**IMPORTANT INFORMATION REGARDING NEW LOG SPLITTER VALVE DETENT
ASSEMBLY DESIGN**

INSTRUCTIONS FOR REPLACEMENT OF LOG SPLITTER VALVE DETENT COVER ASSEMBLY

36561B DETENT COVER ASSEMBLY

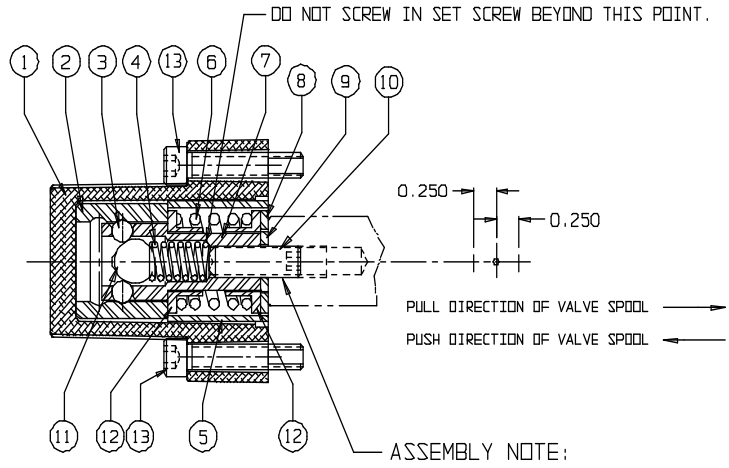
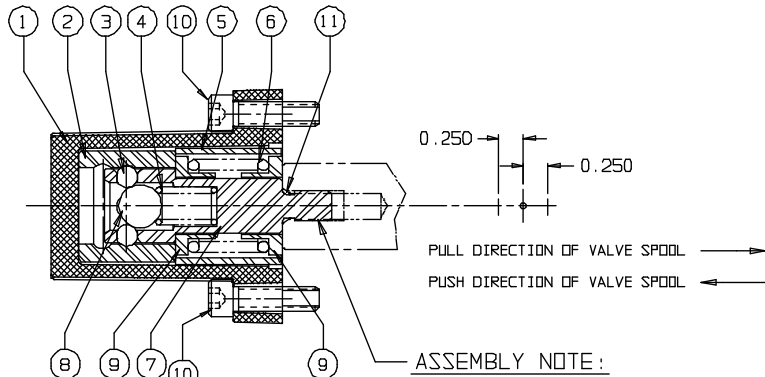
Energy Manufacturing Co., Inc. made design improvements and upgrades to its log splitter valve detent assembly in 2008. The new detent design will directly interchange with all previous detent designs. HOWEVER, the parts within the respective detent assemblies can NOT be interchanged. Interchanging parts between old and new versions may cause the valve to malfunction, potentially creating a safety hazard. When servicing an older model valve with the new detent assembly, make certain you discard the ENTIRE old detent assembly, including ALL internal parts within the old assembly.

****NOTE**** these instructions apply to replacement of the detent cover assembly with 36561B shown below. The 36561B is the latest design. Your valve may have an older design as shown above. The respective assemblies are interchangeable on the valve; however, **DO NOT** interchange parts between the old and new detent assemblies. **Doing so may cause the valve to malfunction, possibly creating a safety hazard.**

2. Remove the screws that retain the valve detent cover (#13 above / #10 below). Remove the detent cover (#1). **Do not** shift the spool or the detent sleeve (#2) will be displaced and allow the detent balls to be released from the ball holder.

3. The ball holder (#7) has screwdriver slots milled in the end. Use a 9/16" wide screwdriver or drag link bit socket adapter to unscrew the detent assembly from the valve spool. If the hex socket set screw (#10, above) remains in the valve spool use vice grips to remove it as well.

5. Apply Loctite® thread sealer or an equivalent compound all around the threads of the stud on the new detent assembly (#7, below). The stud must be sealed oil tight because the center hole in the spool is an oil passage that transmits pressure for the automatic kick out function. Apply only enough thread sealer to assure a sound seal. An excessive application could cause sealant to drip onto the spool and cause it to stick. Torque the detent assembly into the valve spool to 70 – 90 inch-pounds.

6. Place the new detent spring cover (#1, below) over the detent assembly and install the two screws (#10 below) supplied with the kit. Torque screws to 70 – 90 inch-pounds. Check the valve for proper function. **The detent mechanism must function easily and freely in both directions when the lever is actuated by hand.** Allow the thread sealer to cure as recommended by sealer manufacturer before placing the valve in service. If the valve kicks out of the retract mode into any position other than neutral, or if the spool does not move freely in all phases of operation, discontinue use and call factory.
